From: Mark Madar <mmadar58@gmail.com>
Sent: Friday, February 21, 2025 8:19 AM
To: Amanda Krickovich; Gordon Costlow
Subject: 16 Owen Brown- Proposed Changes for Discussions at Feb 26th Meeting

Gordon and I met to review the Historical review report that you had shared for 16 Owen Brown. To align with the historical reviewers recommendations, the following proposed changes are being updated in our design/plan drawings. I would like to have an opportunity to discuss them with the Board at next week's meeting Feb 26th. Gordon is working on incorporating as many as he can in the designs by this weekend to visually walk through at the meeting. I will send to you once I receive back from Gordon.

16 OWEN BROWN ST , HUDSON , OHIO 44236

FRONT ELEVATION

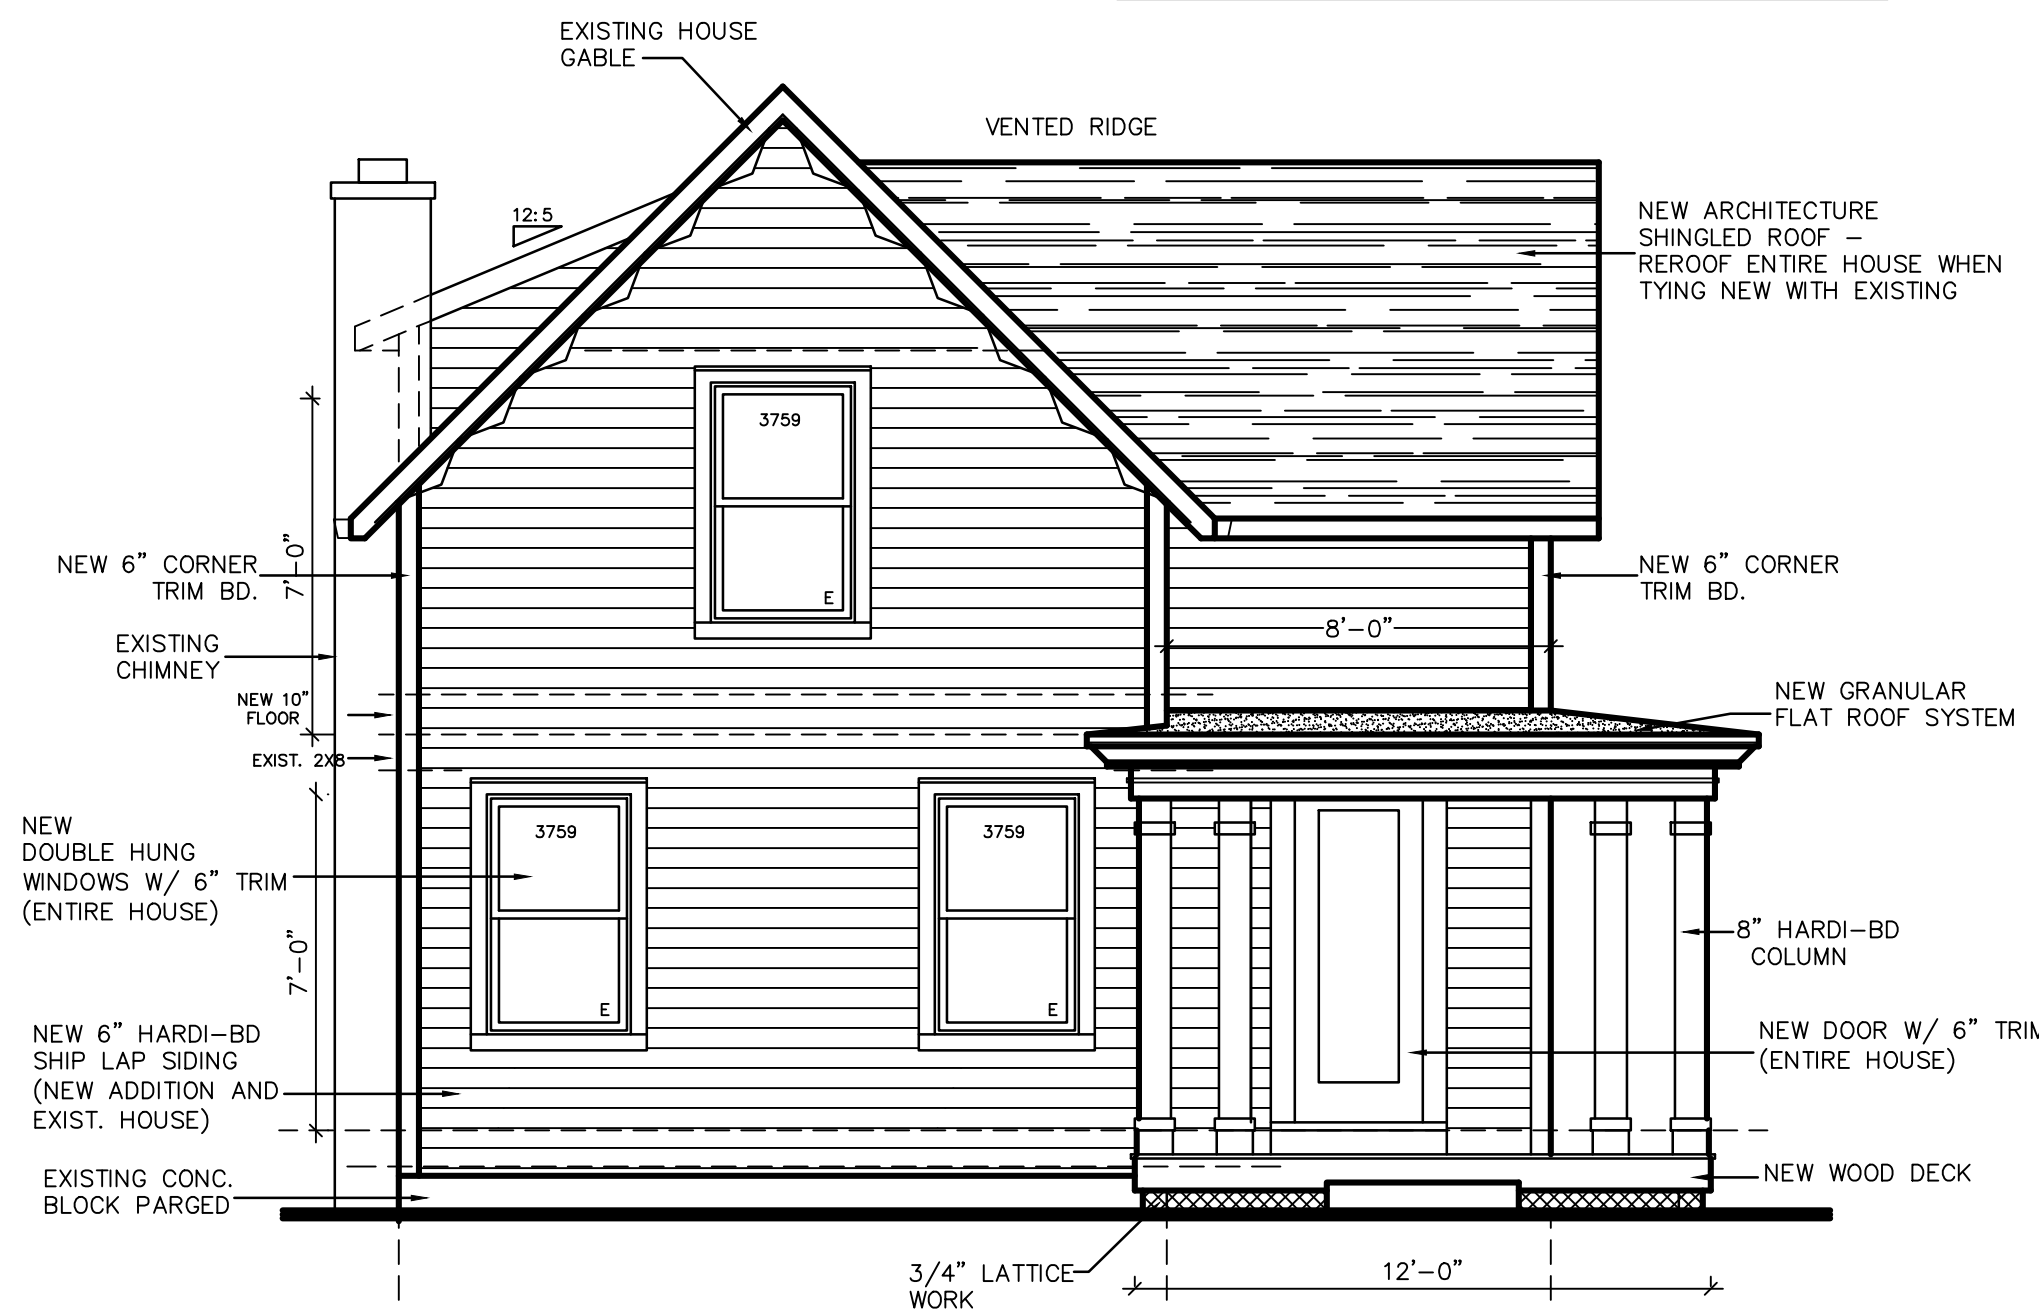
1. Wrap-around front porch that remains within the existing width of house (not to extend past house). Will present design.
2. Lap siding for existing and new addition based on style of home- as suggested by historical review. (remove board batten in design as assimilated with style of home).
3. Replace shed dormer with gable dormers on east elevation as it fits the historical style. Show smaller square windows within gable dormers and align as close as possible with first floor windows for uniformity.
4. Side addition-west elevation- raise gable roof line closer to existing ridge to provide a more similar pitch as the front gable.
5. Inset the sides of the back addition- approx 10 inches
6. Put back the two 1st floor windows in the drawings that were original on the east elevation side of house.
7. Discuss front door (alternative option) such as a window in its place.
